# Rezoning Transportation Analysis

Petition Number: #2022-032

Date	Description
07-26-22	First Review (PDM)
08-23-22	Second Review (WB)
09-28-22	Third Review (JC)

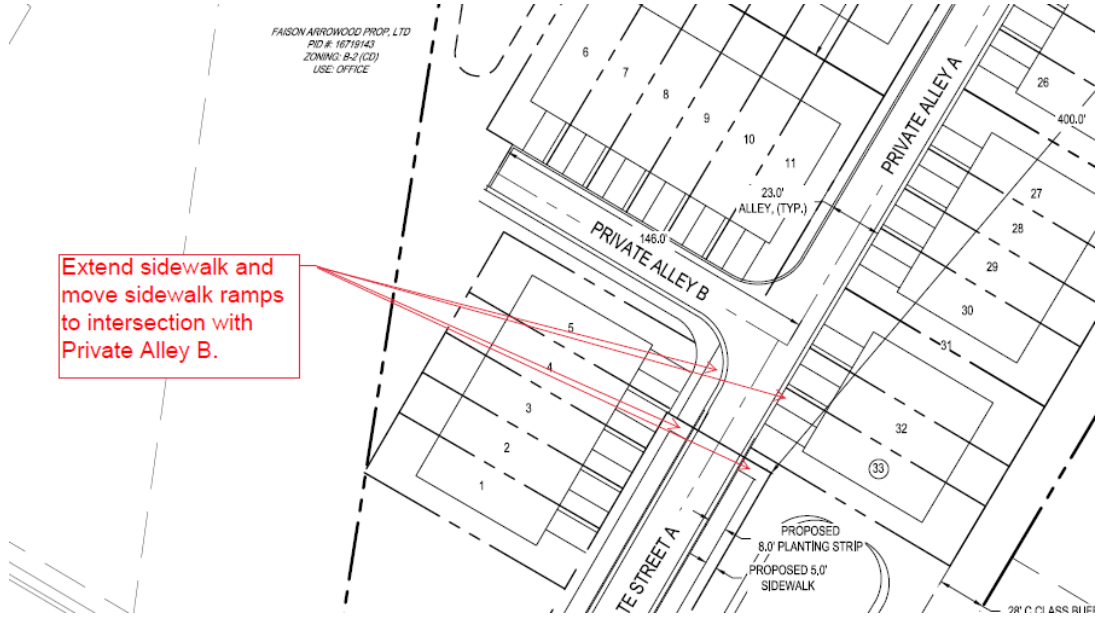
1. **Curbline:** ~~The proposed zoning district has a setback measured from back of the existing or proposed future curblines.~~
  - a. ~~**W Arrowood Road:** The future location of curb and gutter is in its existing location.~~

~~Label and dimension the curb and gutter from the centerline for each road on the site plan.~~
2. **Traffic Study:**
